UNITED STATES ENVIRONMENTAL PROTECTION AGENCY  
WASHINGTON, D.C. 20460

MAR 26 2004

OFFICE OF  
AIR AND RADIATION

#### Review Process

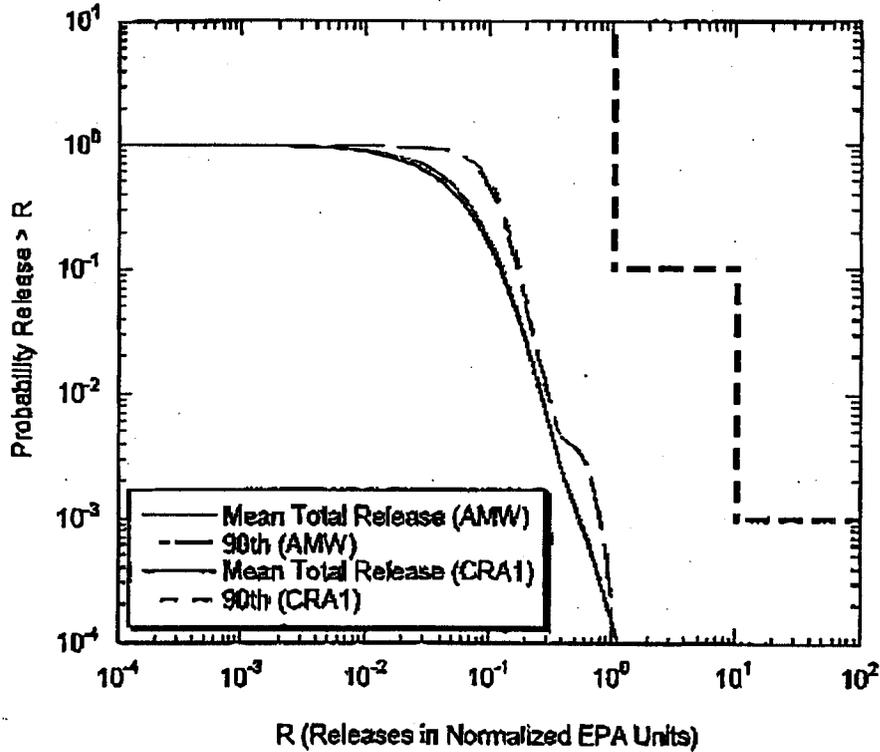
Since the AMW PA inventory and the 2004 CRA use the same inventory, DOE chose to compare the AMW PA with a modified CRA PA<sup>1</sup>. In this comparison, the set of CCDF (cumulative complementary distribution function) curves for total normalized releases are almost indistinguishable. The mean total releases and the 90<sup>th</sup> quantile releases are almost identical. The porosity concerns EPA identified in the review and discussed below should not affect these results because additional analyses showed that important results are not affected by use of constant porosity or porosity surface. EPA's concerns related to the uncertainty are satisfied with a review of the means and 90<sup>th</sup> quantile of total releases presented in Table 1 and Figure 2.

Figure 5-1. Minimum mass of MgO required per waste package.

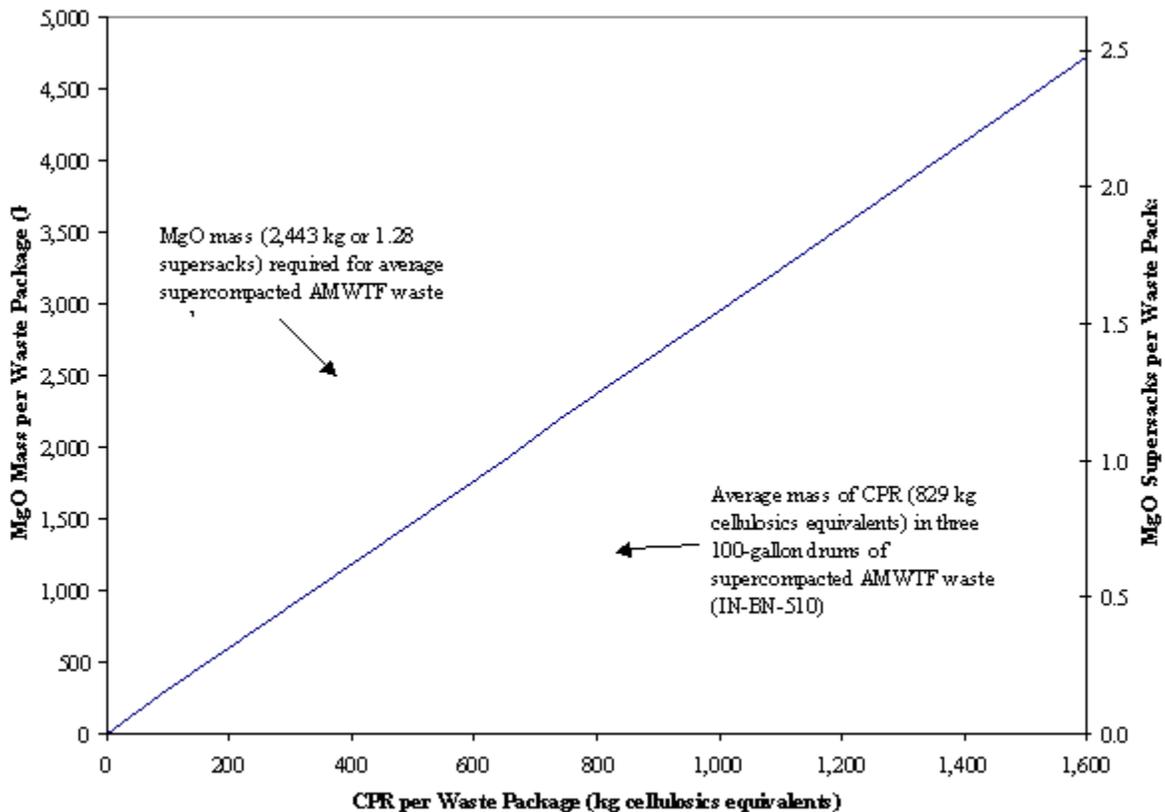
More MgO must be added to the repository than illustrated in Figure 5-1 to allow for the MgO dissolved in brine that may be released from the repository. Such releases can occur through anhydrite interbeds or intrusion boreholes and the MgO removed from the repository would not be available to react with CO<sub>2</sub>. The volume of brine that could leave the repository can conservatively be set equal to the volume of brine that could enter the repository. The amount of MgO that would be dissolved in the maximum volume of brine that could enter the repository is  $4.81 \times 10^5$  kg (Snider, 2003a and 2003b). This would require the placement of an additional 253 MgO supersacks in the repository.
